APPEAL SUMMARY

Appeal ID: 24864	Project Address: 4981 SE Woodstock Blvd
Hearing Date: 5/12/21	Appellant Name: Dan Williams
Case No.: B-004	Appellant Phone: 503-819-7754
Appeal Type: Building	Plans Examiner/Inspector: Guy Altman
Project Type: commercial	Stories: 4 Occupancy: R-2, B Construction Type: V-A
Building/Business Name: Woodstock Apartments	Fire Sprinklers: Yes - Throughout
Appeal Involves: Erection of a new structure	LUR or Permit Application No.: 21-003259-CO
Plan Submitted Option: pdf [File 1] [File 2]	Proposed use: 4 Story mixed-use development

Woodstock Apartments: New 4-story mixed-use apartment building
21-003259-CO; 20-206435-LU

Appeal Item #1: Alternate fire rating for glazing at interior wall in lobby

1 CITY RESP DM1 04/20/2021 GMP SET 03/17/2021 ISSUE DATE Drawing: CODE SUMMARY

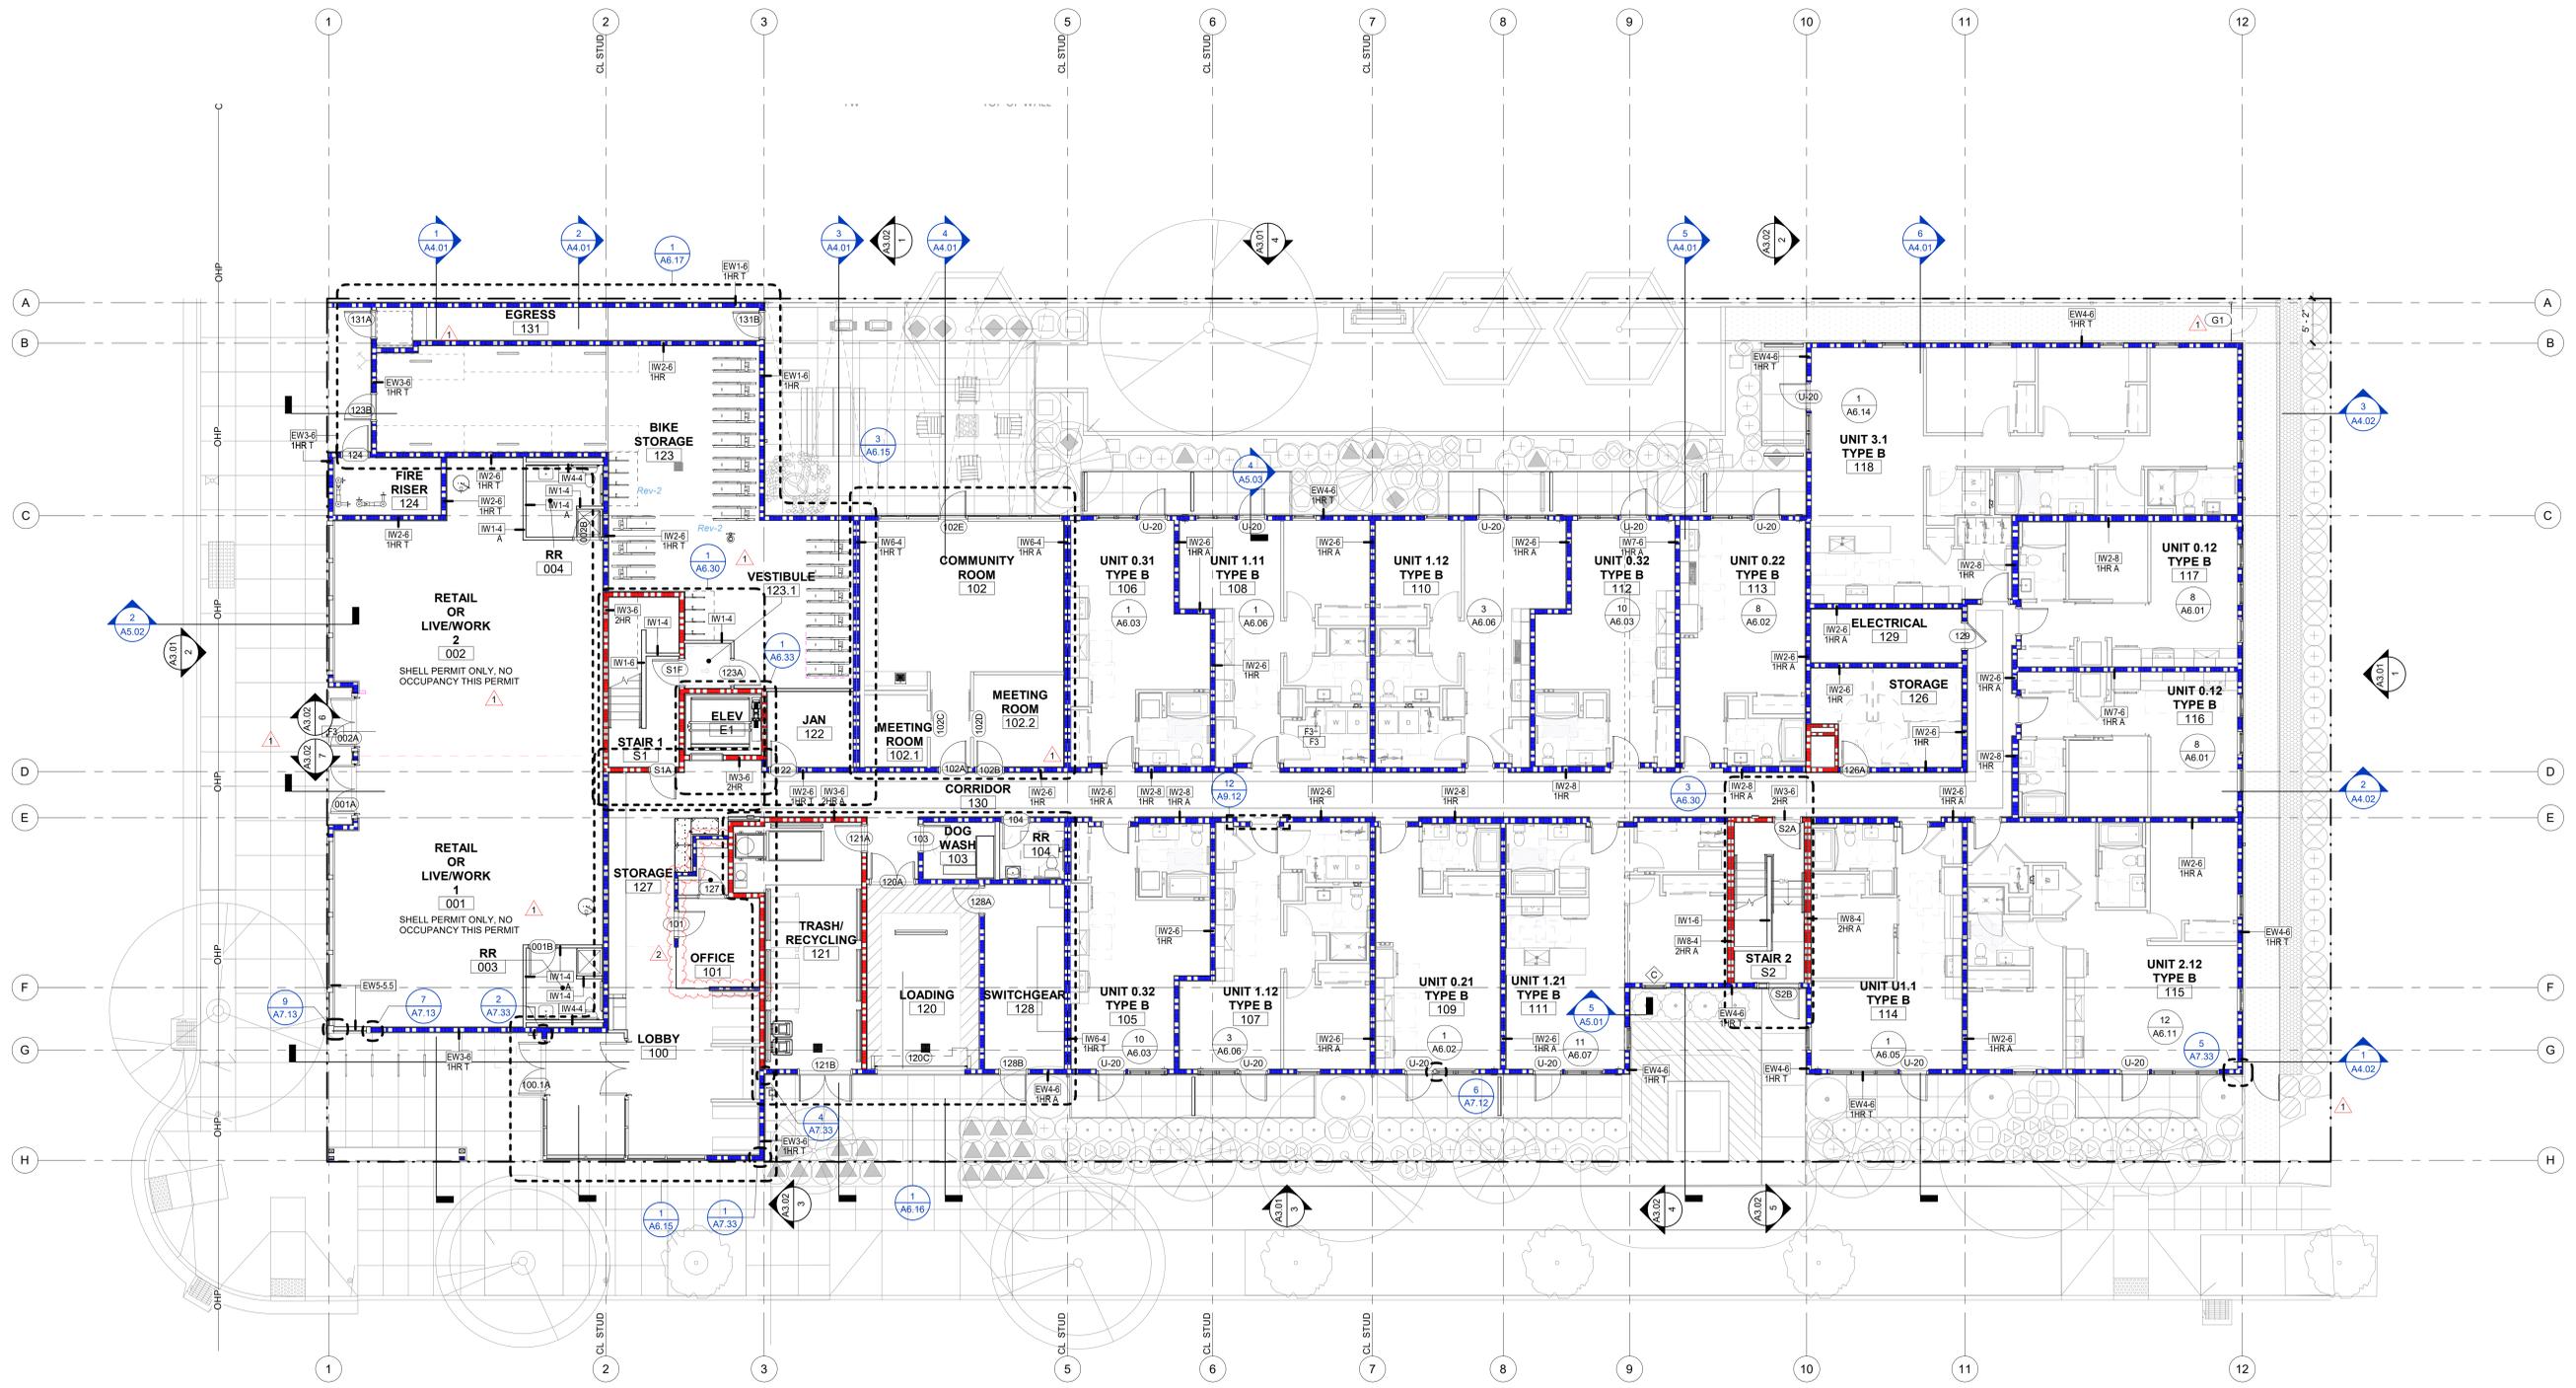
Proposed Design Lobby #100 is required to have 1?2-HR rated fire partition walls forming the exit corridor and lobby enclosure as shown in the attached code summary. Office #101 forms a side of the lobby enclosure and is required to have 1?2-HR fire rated walls. The proposed office relites along this wall are to be safety glazing as shown on the attached interior elevations.

Lobby #100 is required to have 1/2-HR rated fire partition walls forming the exit corridor and lobby enclosure as shown in the attached code summary. Office #101 forms a side of the lobby enclosure and is required to have 1/2-HR fire rated walls. The proposed office relites along this wall are to be safety glazing as shown on the attached interior elevations.

Type 13 water curtain sprinkler protection at non-fire rated openings in 1/2 hour fire rated corridor: Granted provided windows are non-operable, fixed glazing doors are on closers and sprinklers are spaced not more than 6 feet apart and placed a minimum of 6 inches and a maximum of 12 inches from the opening(s) and a maximum of 12 inches below the ceiling. Sprinklers are to be installed on the occupied side of the openings. A separate permit from the Fire Marshal's Office is required. Appellant may contact John Butler (503 865-6427) or e-mail at John.Butler@portlandoregon.gov with questions.

1 LOBBY FLOOR PLAN
1/4" = 1'-0"

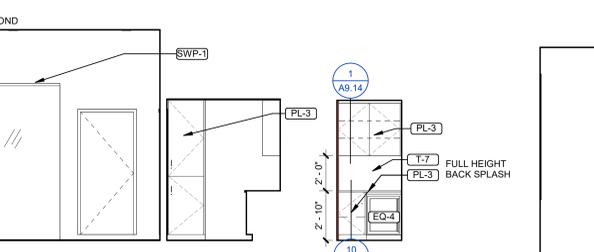
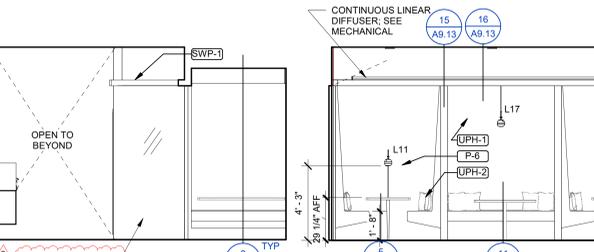
The proposed building will have a NFPA 13 compliant sprinkler system throughout the building. To achieve the required minimum corridor 1?2-HR fire- resistance rating at the proposed safety glazing sections of this room enclosure, it is proposed to use a sprinkler system curtain that meets NFPA 13 standards for fire protection of non-rated glazing assemblies.

The proposed building will have a NFPA 13 compliant sprinkler system throughout the building. To achieve the required minimum corridor 1/2-HR fire-resistance rating at the proposed safety glazing sections of this room enclosure, it is proposed to use a sprinkler system curtain that meets NFPA 13 standards for fire protection of non-rated glazing assemblies.
